CITY OF  
**West Linn**  
 PLANNING AND DEVELOPMENT

**PLANNING DIRECTOR DECISION**

FILE NO.: MISC-13-05

REQUEST: Request for a Flood Management Area (FMA) permit for additions to an existing house at 19220 Nixon Ave.

Figure 2: Flood Designations in Relation to Proposed Development

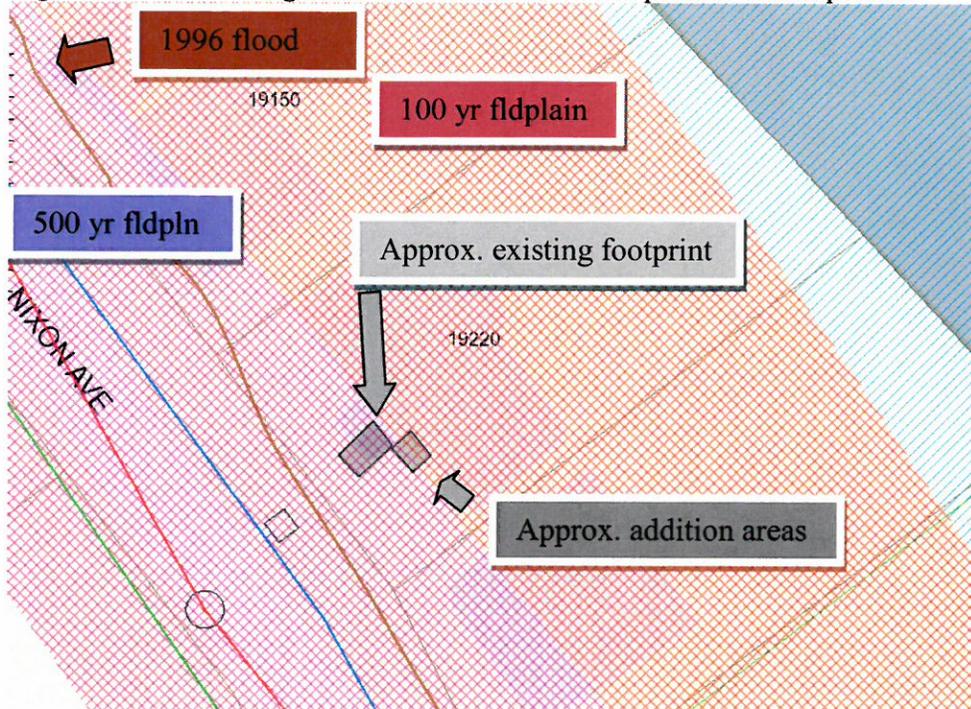
The application requests Flood Management Area approval for new outdoor front entrance stairway and for a small front interior addition. Both of these areas are within the 1996 Flood Line, and the area of the addition is partly within the 100-year floodplain. Per Section 27.010 the Flood Management Area consists of areas within the floodway, the 100-year floodplain and/or the 1996 Flood Line. Per Section 27.020 any development in the Flood Management Area (FMA) requires FMA approval. Therefore the applicant has applied for FMA approval.

The applicant proposes a small addition to the house totaling approximately 61 square feet and a new outdoor front stairway to the second floor front entrance; the stairway has a footprint of approximately 190 square feet (including areas where the stairway does not touch the grade).

Figure 3 Applicant's Plan Showing Proposed Stairs and Addition (Interior addition is just above and to the right of the stairs in this view):

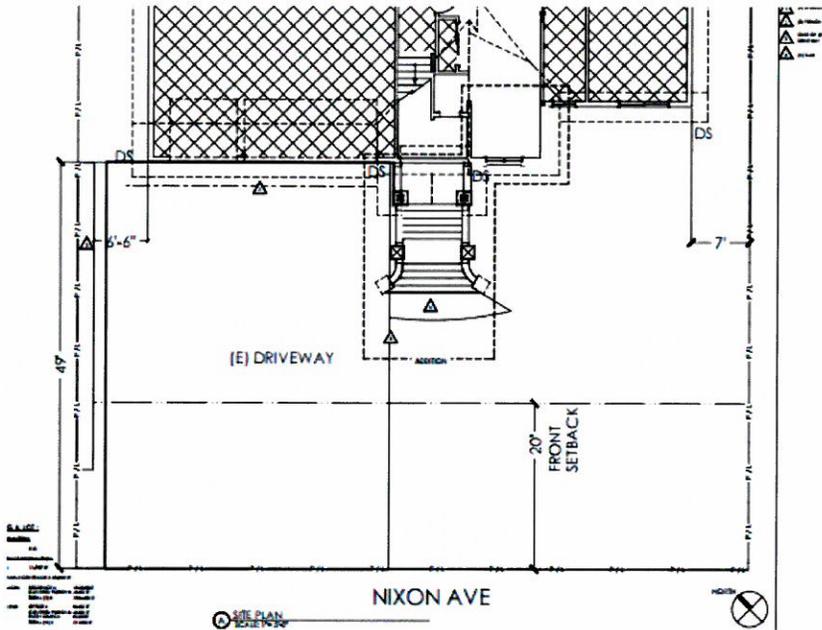
The 100-year or base flood elevation is 46 feet in this area per City GIS. The applicant proposes to build the new habitable interior space at 49.1 feet in elevation which puts this at three feet above the base flood elevation. An Oregon licensed engineer's findings accompany the application (see Page 22 of Exhibit PD-3). These findings have determined that the addition and the enlargement will not have any adverse impacts on floodwaters or modify existing flood patterns.

By using FEMA's 46-foot base flood elevation, in concert with the applicant's elevations on the submitted Site Plan on Page 48 of Exhibit PC-3, an accurate delineation of the expected height of floodwaters was provided for this property.

1. The home additions shall be constructed consistent with the Site Plan Sheet A1.0, dated May 30, 2013, on Page 48 of Exhibit PD-3.

2. The applicant shall make necessary excavation on this property to compensate on an equal cubic yard to cubic yard basis for all water displacing structures (foundation walls, slab on grade, etc.) below 46 foot elevation.
